**SUBJECT: Wireless Telecommunications Facility Permit Application
(T-Mobile Site # LA33664E)**

NOTICE OF INCOMPLETENESS

**Subject: First Screencheck Comments - Wireless Telecommunication Facility
Permit T-Mobile Site #LA33664E; W/O 10876 Culver Blvd**

**ATTACHMENT 1
FIRST SCREENCHECK COMMENTS
WIRELESS TELECOMMUNICATION FACILITY PERMIT
T-MOBILE SITE #LA33664E – W/O 10876 CULVER BLVD**

Sheet D-2

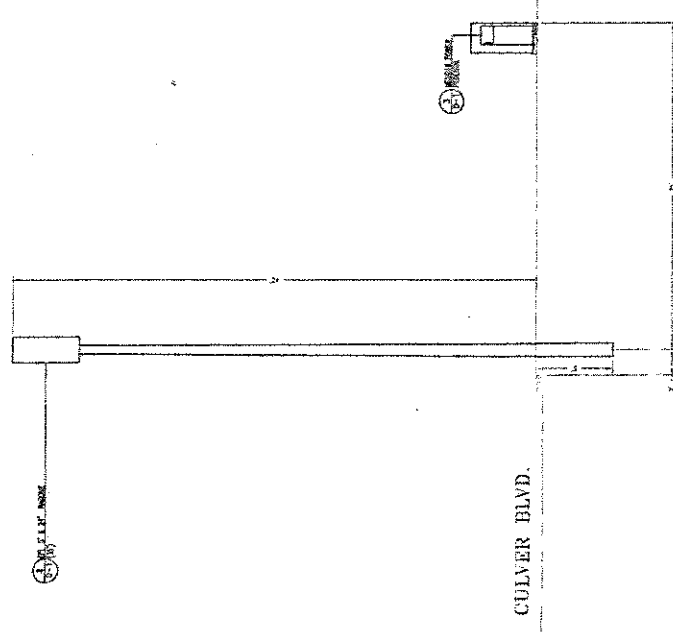
39. Decrease the size of the concrete pad to minimize the impact to the landscaped parkway.
40. Provide landscape screening around ground equipment. Depict landscaping on Sheet D-2.

SHEET NUMBER:
A-3

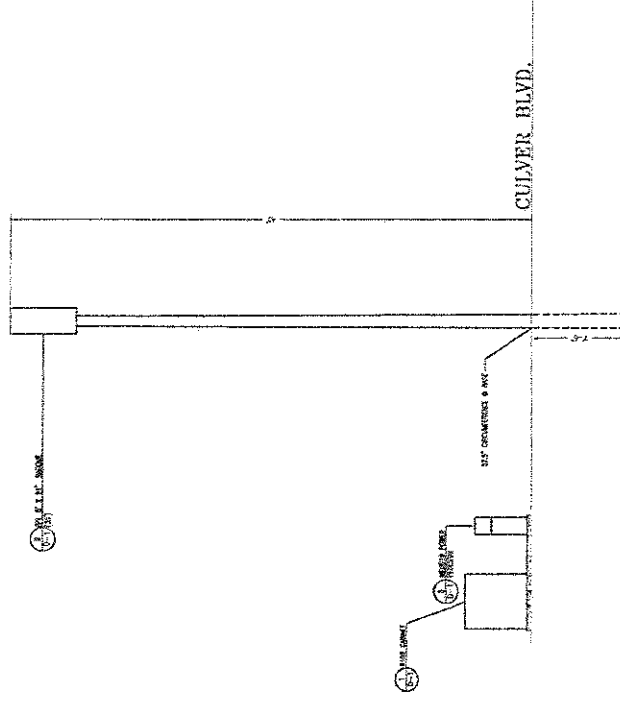
32. Add a note to the plans specifying the color of the pole. The pole shall be a neutral, non-glossy color.
33. Add a note to the plans indicating that the radome will be painted to match the color of the pole.
34. Add a note to the plans indicating that the equipment cabinet will be painted to match the color of the pole.
35. Add a note to the plans indicating that all cables shall be fully concealed.
36. Add a note to the plans that a sign shall be placed on the equipment cabinet that lists a telephone number to contact in case of emergency.
37. Provide a slimmer radome that is more in scale with the pole.

Notes: - Specify color of pole

- Indicate Pole name will be painted to Match pole color
- Indicate Address will be fully connected
- Indicate a sign will be placed on cabinet with phone number for Emergency Contact.

SHEET TITLE:
EQUIPMENT
DETAIL
 SHEET NUMBER:
D-1

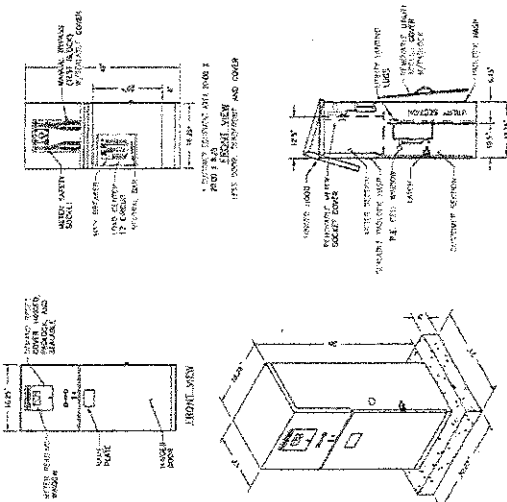
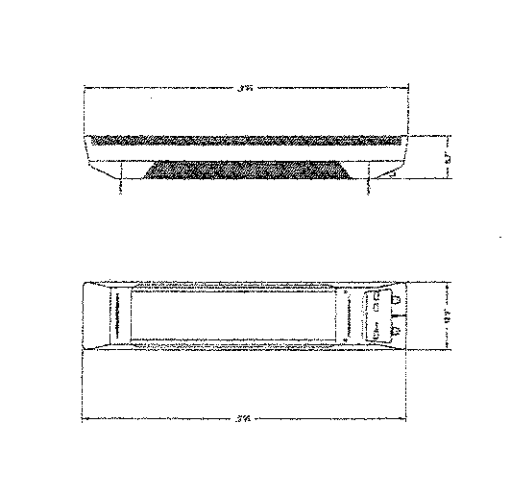
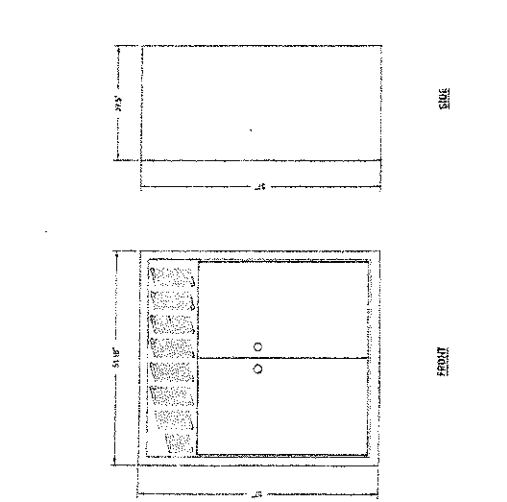
38. Provide detail for radome including height and diameter dimensions

<p>FRONT VIEW SIDE VIEW REAR VIEW</p>	<p>3 MEUG16 POWER PEDESTAL SCALE: N.T.S.</p>	6
 <p>GENERAL ANTENNA INFO SCALE: N.T.S.</p>	<p>2 GENERAL ANTENNA INFO SCALE: N.T.S.</p>	5
 <p>CABINET DETAIL SCALE: N.T.S.</p>	<p>1 6102 CABINET DETAIL SCALE: N.T.S.</p> <p><i>Provide detail for radome.</i></p>	4
